**CITY OF TEMPE  
DEVELOPMENT REVIEW COMMISSION**

**Meeting Date: 02/11/2014  
Agenda Item: 5**

**ACTION:** Request for a Development Plan Review consisting of a new drive thru restaurant building for CULVERS RESTAURANT located at 630 East Southern Avenue. The applicant is Evergreen Devco.

**DEVELOPMENT PROJECT FILE**  
for  
**CULVER'S RESTAURANT**

**1 SITE PLAN**

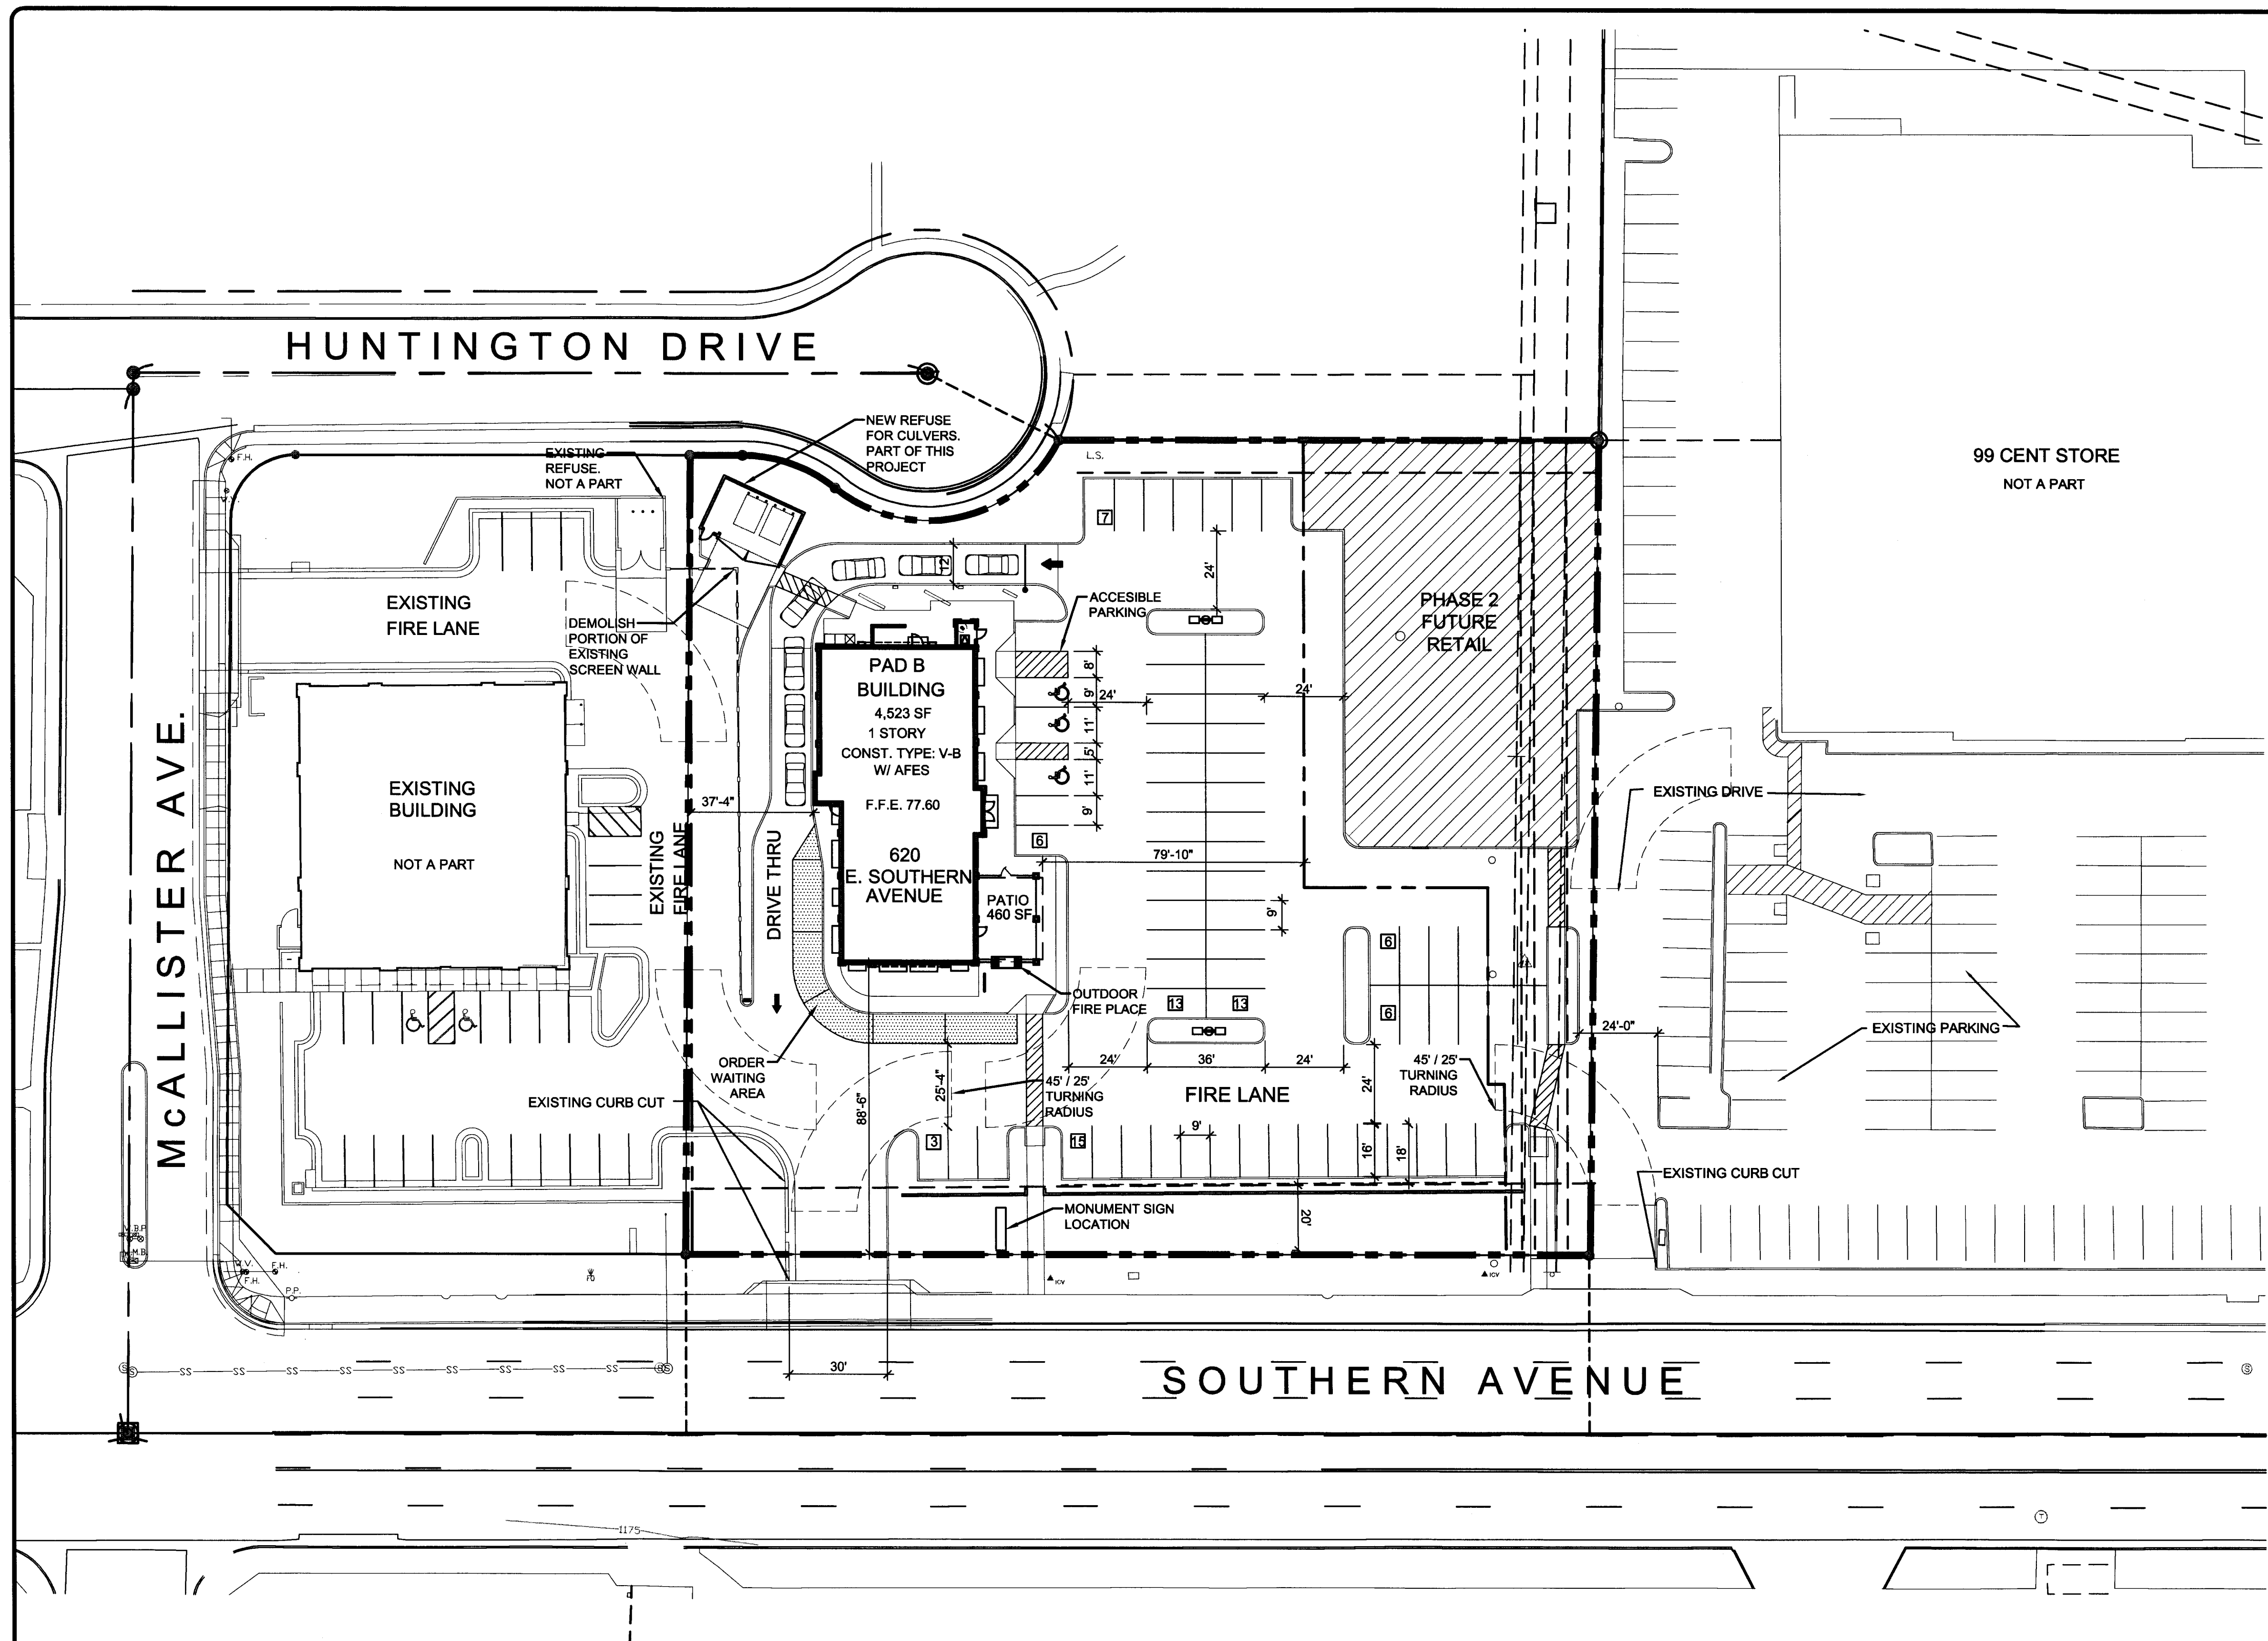
1. Utility equipment boxes for this development shall be finished in a neutral color (subject to utility provider approval) that compliments the coloring of the buildings.
2. Continue site perimeter wall to the west along the north property line.
